## HISTORIC AND DESIGN REVIEW COMMISSION

November 17, 2021

**HDRC CASE NO:** 2021-537  
**ADDRESS:** 312 W AGARITA AVE  
**LEGAL DESCRIPTION:** NCB 3058 BLK 5 LOT 8 W 6 FT OF 9 & E 10 FT OF 7  
**ZONING:** R-5  
**CITY COUNCIL DIST.:** 1  
**DISTRICT:** Monte Vista Historic District  
**APPLICANT:** Alan Neff/36square  
**OWNER:** Perry Balleza  
**TYPE OF WORK:** Demolition of accessory structure with new construction  
**APPLICATION RECEIVED:** October 19, 2021  
**60-DAY REVIEW:** Not applicable due to City Council Emergency Orders  
**CASE MANAGER:** Katie Totman  
**REQUEST:**

1. Demolition the existing rear accessory structure.
2. Construct a 2-story garage located at the rear of the property.

**01 DEMOLITION FLOORPLAN**  
 SCALE 1/8" = 1'-0"

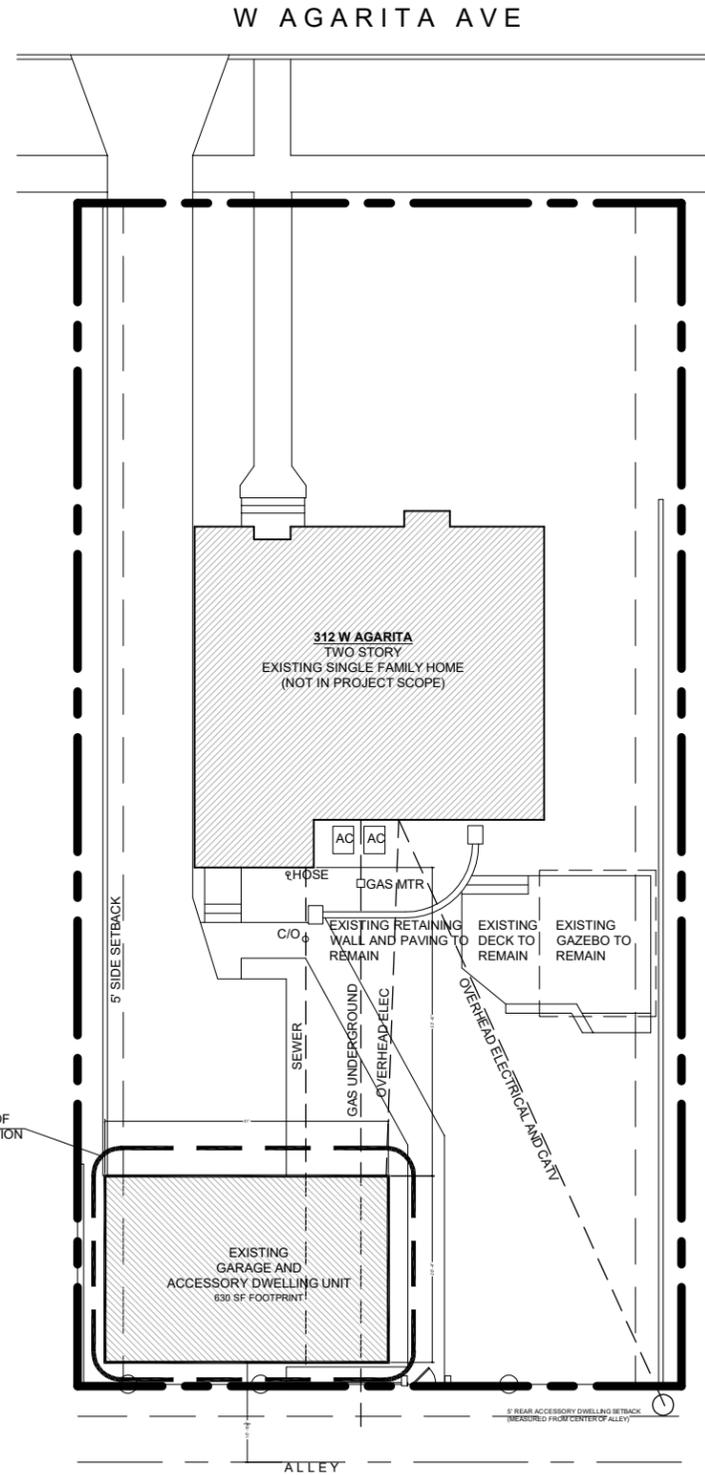
c. CONTRIBUTING STATUS – The existing rear accessory structure is a 1-story, two-bay auto structure that may have been constructed circa 1950-51 based on Sanborn map research. A rear accessory structure matching the footprint of the existing rear accessory structure first appears on the Sanborn Map in 1951. The structure is of wood construction with wood siding, a side gable shingle roof, wood sliding garage doors, and two wood windows. Staff finds that the structure is contributing to the district.

directly or indirectly by the owner and were not due to intentional or negligent destruction or a lack of maintenance rising to the level of a demolition by neglect. The existing rear accessory structure shows evidence of minor wood rot in areas along the slab foundation, termite damage on the interior of one of the garage doors, and wood rot at one of the windowsills. The applicant shared with staff that there was a recent water leak in the garage that caused damage.

Staff does not recommend approval of request item 1 based on findings a through c and 1c.

**03 PROPOSED SITE PLAN**

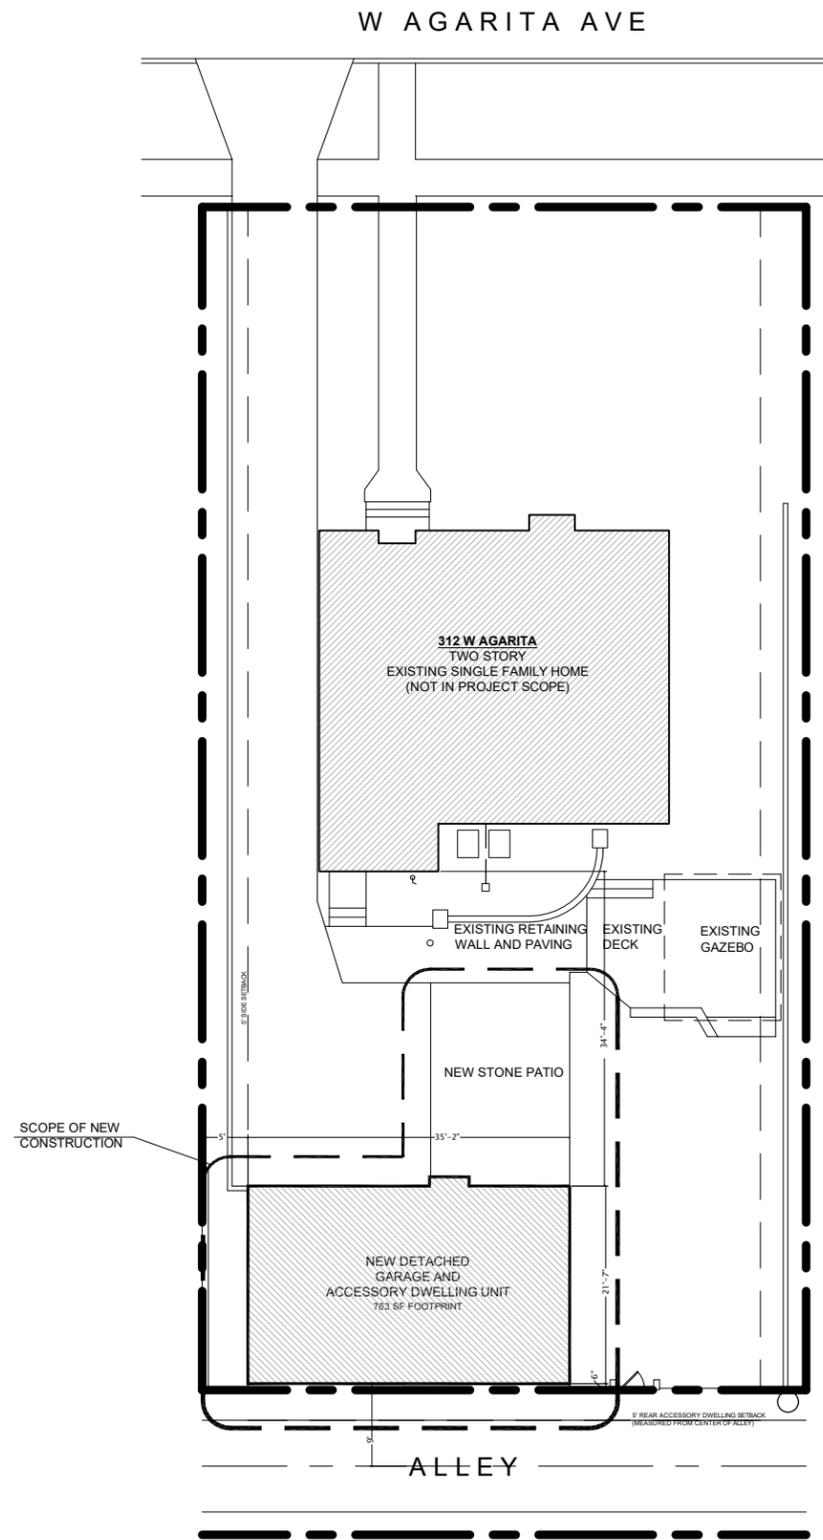
2a. SETBACKS & ORIENTATION – The applicant has proposed to construct a rear garage in place of the existing rear accessory structure. According to the Guidelines for New Construction, the orientation of new construction should be consistent with the historic example found on the block. The applicant has proposed to orient the new garage at the rear of the property abutting the rear alley, which reflects that of the historic structure currently on the site. Staff finds that the proposed orientation and setback of the new garage are consistent with the design guidelines.

2c. FOOTPRINT – The applicant has proposed a footprint of approximately 765 square feet for the new garage. According to the Historic Design Guidelines, new construction should be consistent with adjacent historic buildings in terms of the building to lot ratio. The existing rear accessory structure is approximately 630 square feet. The proposed garage will be generally comparable in total square footage to the existing rear accessory structure. Staff finds that the proposed footprint is consistent with the Guidelines.

**01 NORTH ELEVATION**  
 SCALE 1/8" = 1'-0"

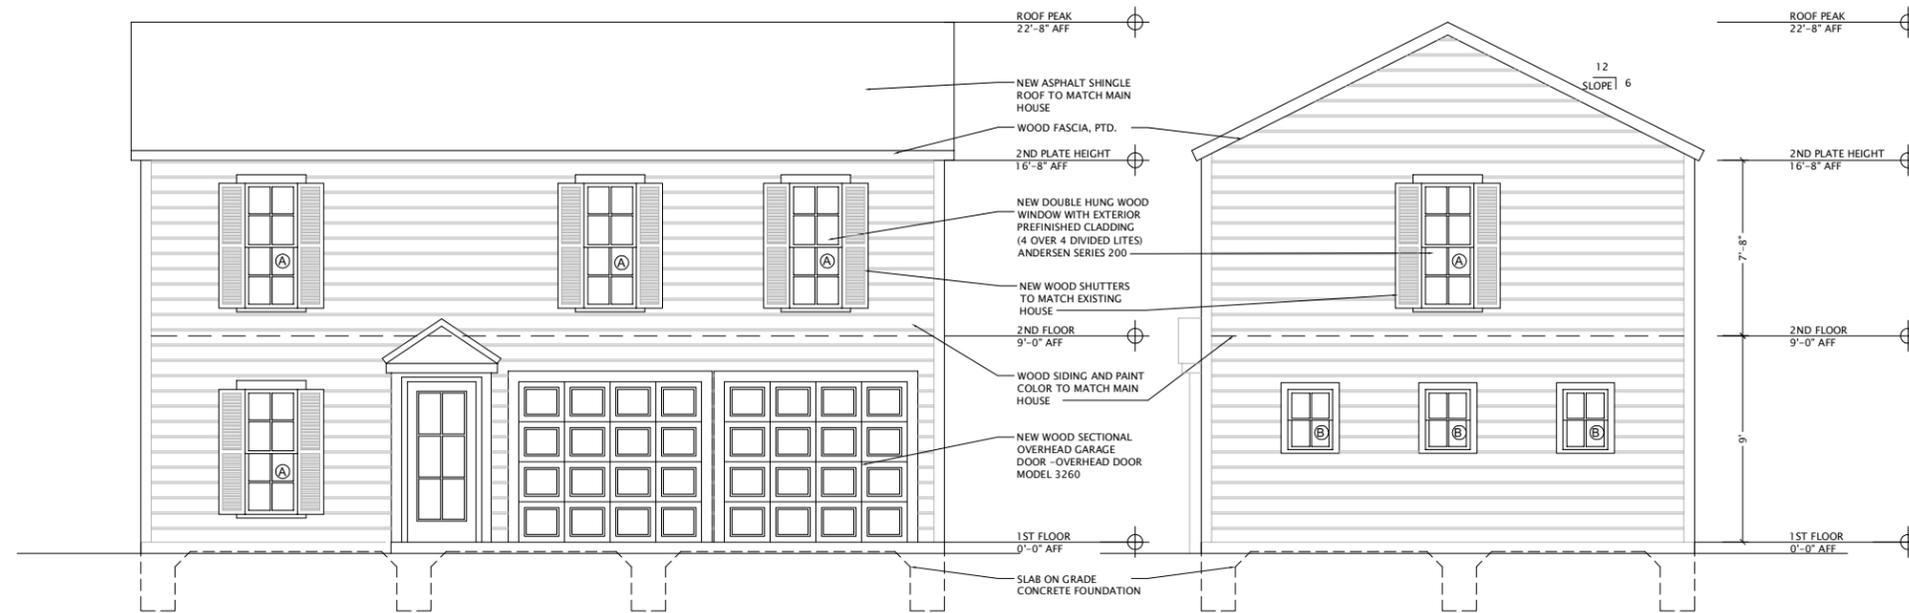
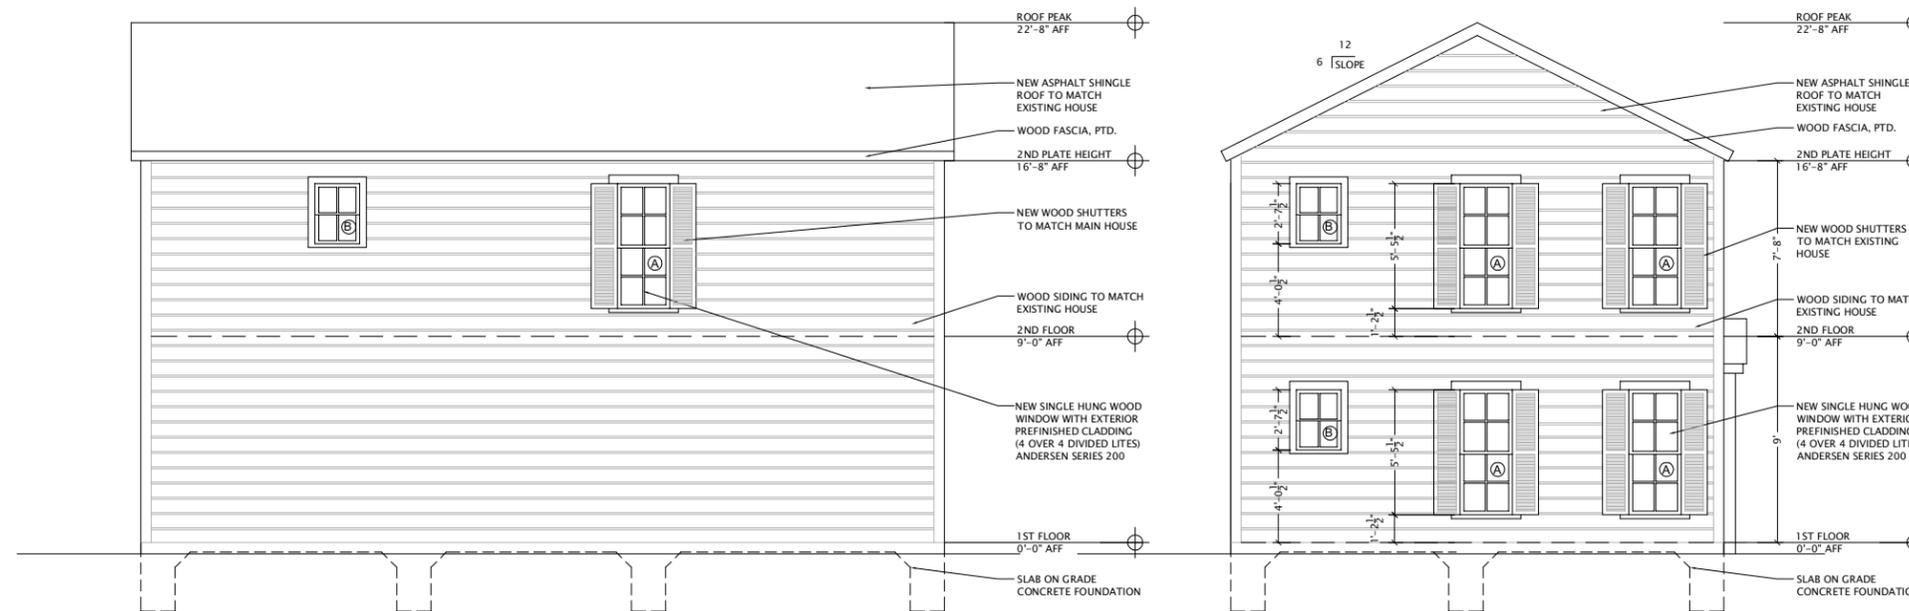
2b. SCALE & MASS – The applicant has proposed a 2-story garage structure with a side gable roof. The structure will measure approximately 22'-8" in height at the roof peak and approximately 16' at the second-floor roof plate. The Historic Design Guidelines state that new construction should be consistent with the height and overall scale of nearby historic buildings and rear accessory structures. The primary structure on this lot is 2-stories as is the neighboring structure to the east. Although the existing accessory structure is 1-story, staff finds that the scale of the proposed structure does not visually compete with the primary structure on the lot or nearby historic structures. Staff finds the proposal generally consistent with the Guidelines.

2d. ROOF FORM – The applicant has proposed a side gable roof form. Guideline 2.B.i for New Construction states that new construction should incorporate roof forms – pitch, overhangs, and orientation – that are consistent with those predominantly found on the block. The roof form on the existing rear accessory structure is a side gable roof form. Staff finds the proposal appropriate.

2e. MATERIALS – In the submitted elevation drawings, the applicant notes that the new garage will feature materials comparable to those found on the primary historic structure. This includes an asphalt shingle roof, wood siding, four-over-four vinyl clad wood windows, and shutters. The existing accessory structure features wood lap siding and an asphalt shingle roof. Staff finds that the proposed materials are generally consistent with the Guidelines apart from the windows. The proposed windows should be consistent with staff's standard stipulations as noted in the recommendation below and the shutters be proportionate to the sizes of the windows.

2f. ARCHITECTURAL DETAILS – New structures should be designed to reflect their time while representing the historic context of the district. Additionally, architectural details should be complementary in nature and should not detract from nearby historic structures. The garage structure overall is simple in design and features a pediment over the entrance door. Staff finds the architectural details to be appropriate.

Staff recommends approval of request item 2, the construction of a rear accessory structure, based on findings 2a through 2f with the following stipulations:

- i. That materials from the historic accessory structure including wood siding, windows and doors be salvaged and stored on site for use in future construction.

- ii. That the proposed windows meet the following stipulations:
  - **SIZE:** Windows should feature traditional dimensions and proportions as found within the district.
